Application for Variation of an Environmental Permit

C1. Name of the Current Environmental Permit Holder :  
Civil Engineering and Development Department  
C2. Application No. of the Current Environmental Permit : AEP-591/2021  
C3. The Current Environmental Permit was Issued in : month / year  
[05] [2021]

**Joint Cavern Development at Anderson Road Quarry Site  
– Reprovisioning of Public Works Central Laboratory and  
Building of Government Records Services' Archives Centre**

**Environmental Review Report for Rock Cavern Development for  
Relocation of Public Works Central Laboratory Building and  
New Archives Centre**

PROPOSED DESIGN CHANGE

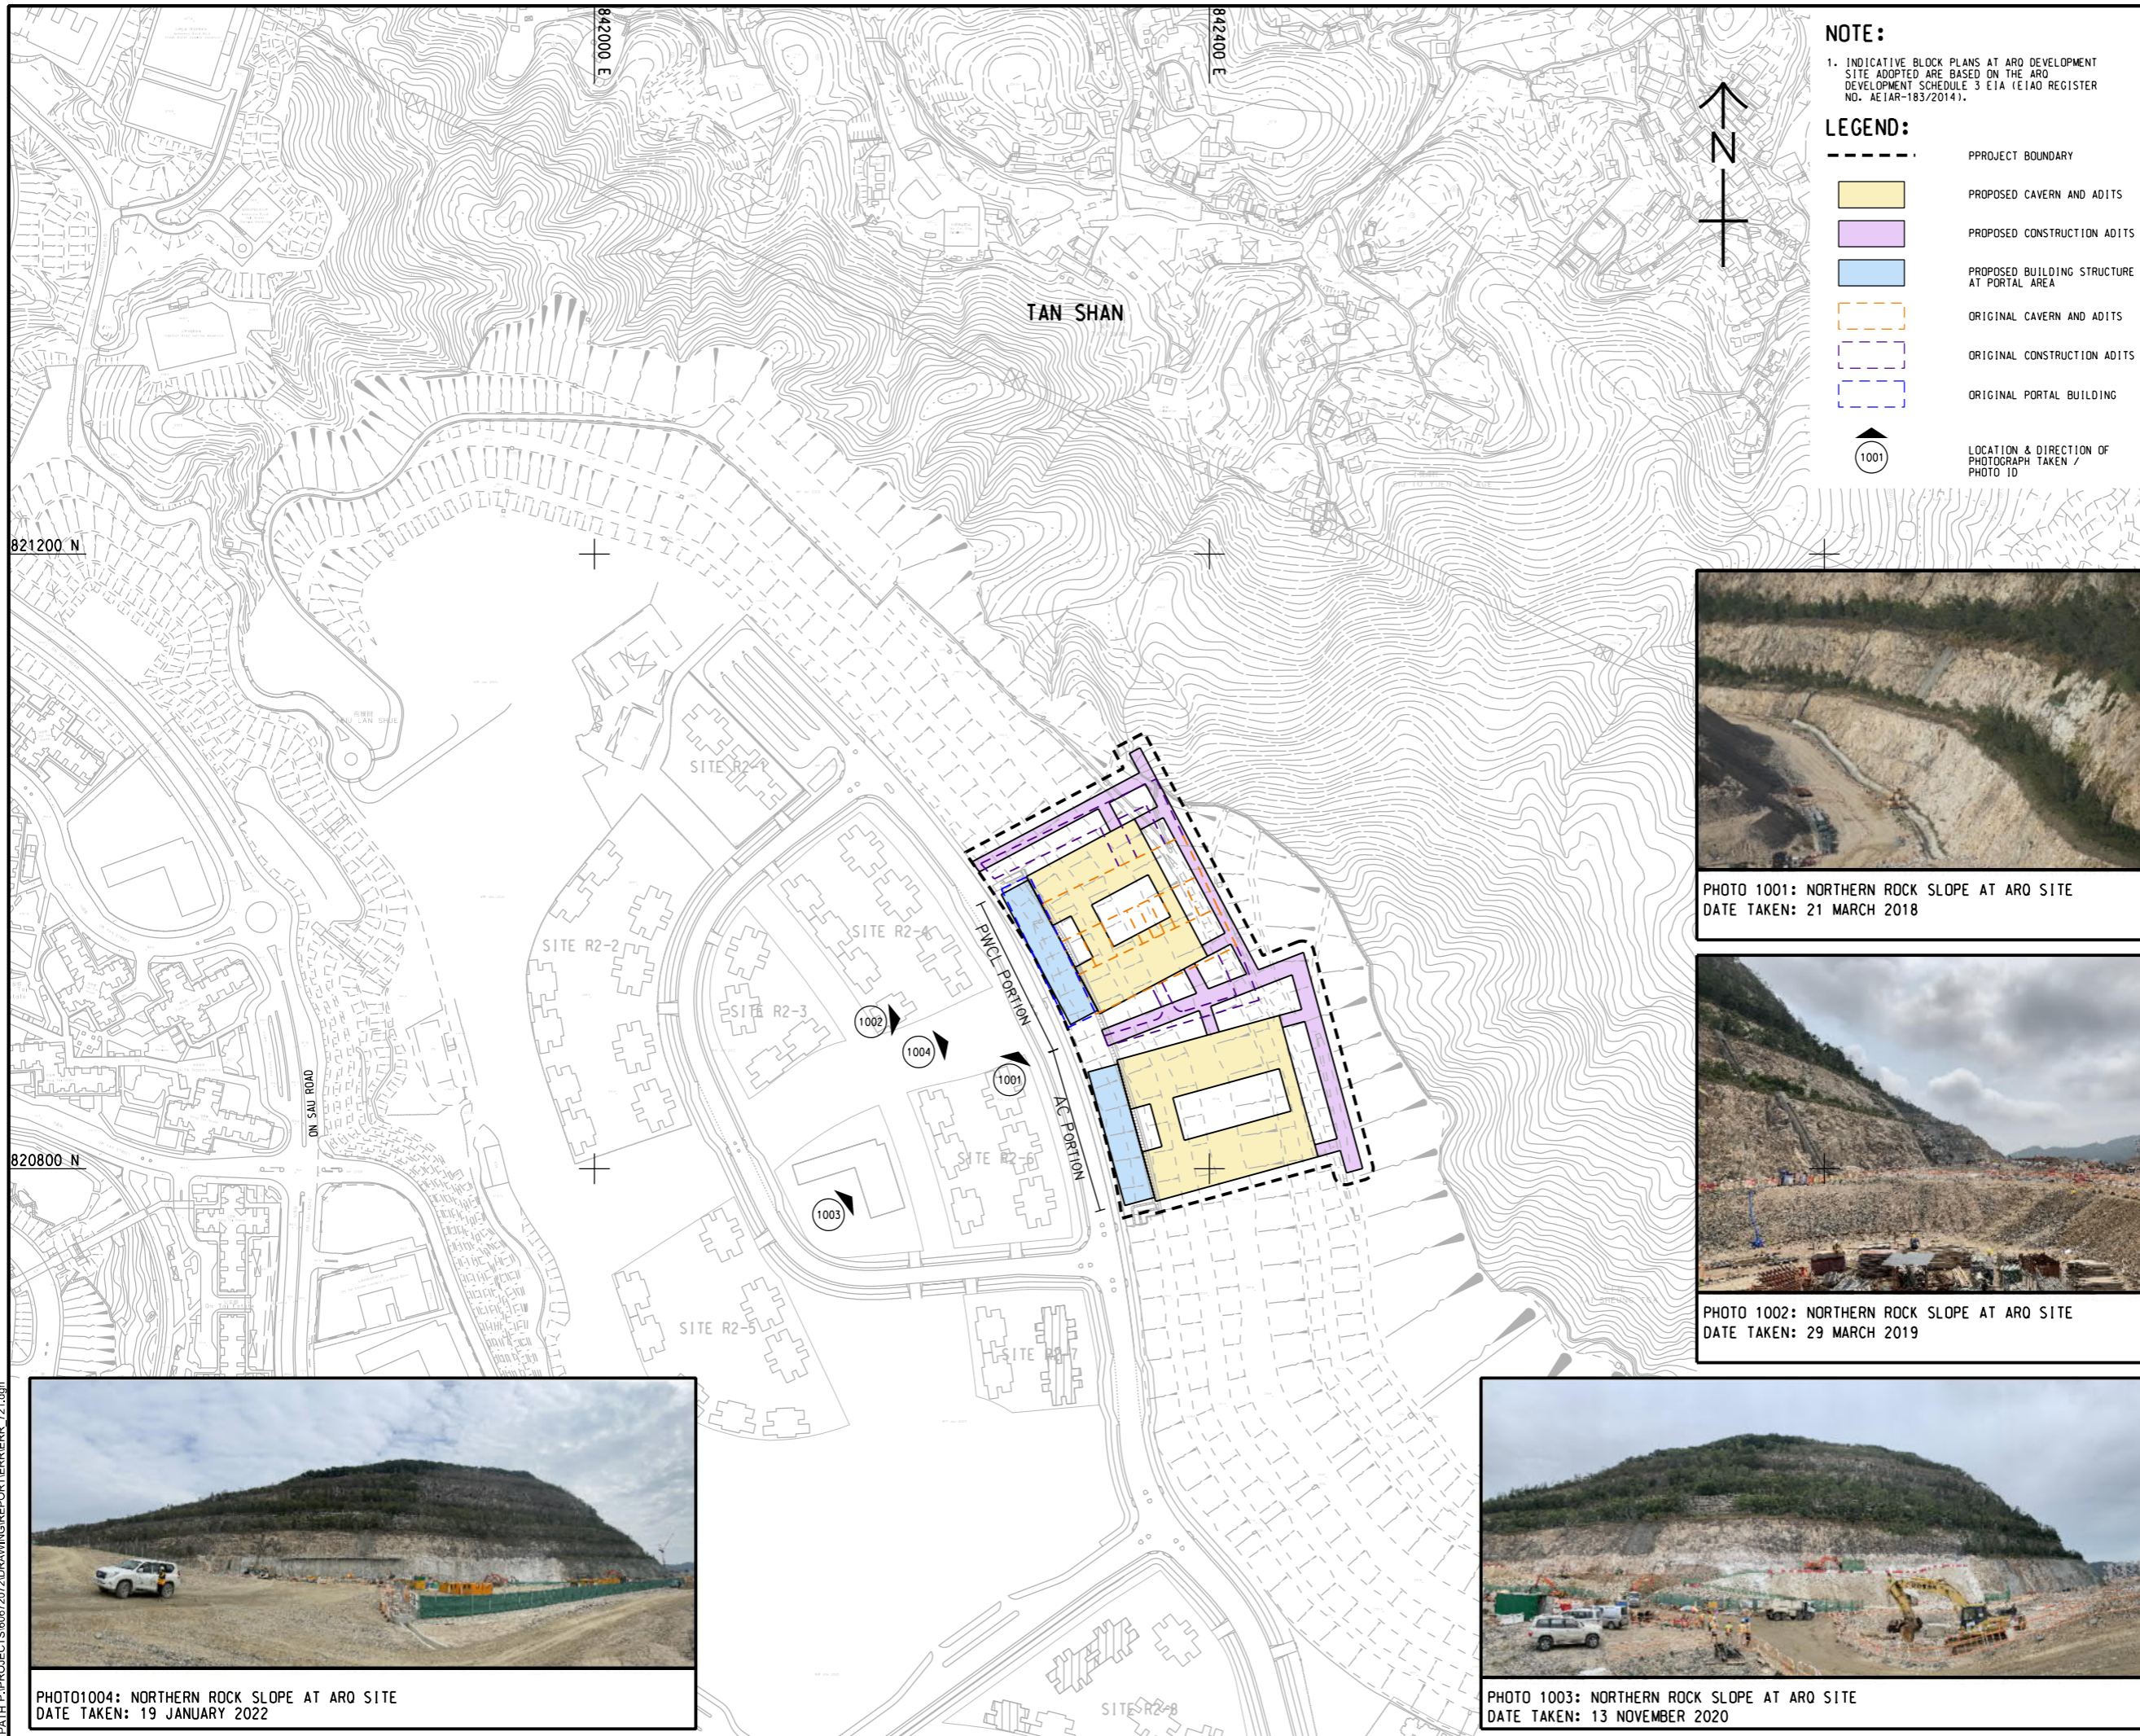
- Change of rock cavern dimensions for the PWCL Portion – Taking into account the updated future tenants of the Reprovision PWCL Building, in order to cater for the operational requirements and to enhance the connectivity within the cavern, the dimensions of the caverns of the PWCL Portion have been optimised from approximately 2 x 25m(W) x 28m(H) x 100m(D) to approximately 2 x 33-36m(W) x 27-29m(H) x 80m(D) (**Figure 2.1** refers).

- Addition of a building structure for the AC Portion of the cavern development adjacent to the portal area and building structure proposed for the PWCL Portion (**Figure 2.1** refers).

- 2.5.3 Given that there are no major changes in the existing / planned land uses (currently as bare rock slope surface, refer to the site photos in **Figure 2.1**) upon completion of Schedule 3 EIA study for Development of Anderson Road Quarry (EIAO Register No. AEIAR-183/2014 approved without conditions on 28 Jul 2014) ("ARQ Development Sch.3 EIA) and no ecological or cultural heritage / archaeological resources (such as Site of Archaeological Interest (SAI), Declared Monuments and archaeological potential areas) identified within or in the vicinity of the proposed enlarged works area, no ecological impacts, cultural heritage impacts or land contamination issues would be envisaged. No further review of these potential environmental impacts is considered necessary. Nevertheless, if there are any buildings / structures both at grade level and underground which were built in or before 1969, or discovery of antiquities or supposed antiquities in the course of works, the Antiquities and Monuments Office (AMO) should be alerted in an early stage or once identified.
